Domiciliary Project Questions from 8/22/2014

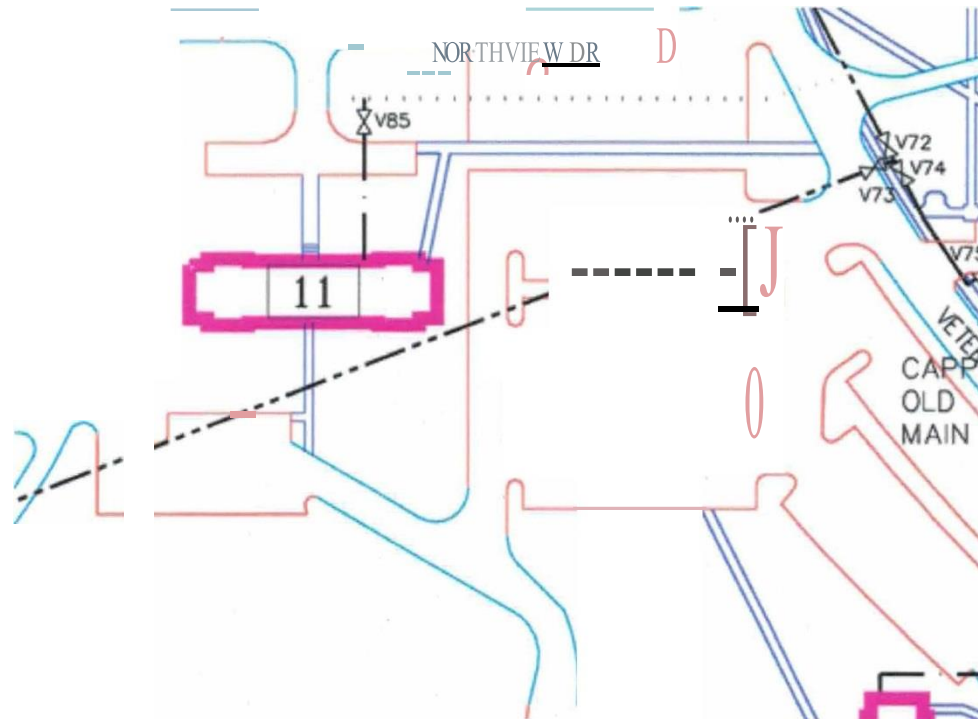
32. Please identify the size of the domestic water line shown in the image. (see below) Does this water line need to be rerouted so it does not interfere with civil/site work for the new building? [Contractor may not build over it or any other utilities. Size of line to be verified by contractor.](#)
